GORDONSVILLE, VA
164 CAMPGREEN RD
STORE # 4162-03

1	REV #1	04/16/18
2	REV #2	04/25/18

REFRIGERATION PLANS

SHEET: R1

2 REAR REFRIGERATION PLAN
1/8" = 1'-0"

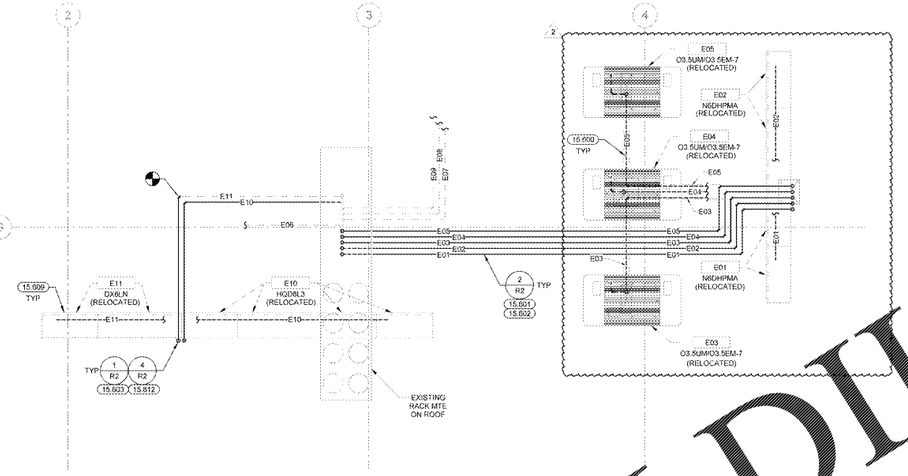
2 ADD KEYNOTE 15.609

2 REMOVE KEYNOTE 15.618

15.609	PROVIDE PVC DRAIN LINE FROM EACH CASE DRAIN CONNECTION SAME SIZE AS CASE OUTLET, AND END OVER FLOOR DRAIN W/AIR GAP. PITCH DRAINS 1" PER 10'.
15.612	PROVIDE INTERMEDIATE SUCTION LINE TRAP IN WALL OR VOID SPACE. INTERMEDIATE TRAP SHOULD BE PLACED AT THE MIDPOINT OF THE SUCTION LINE RISER.
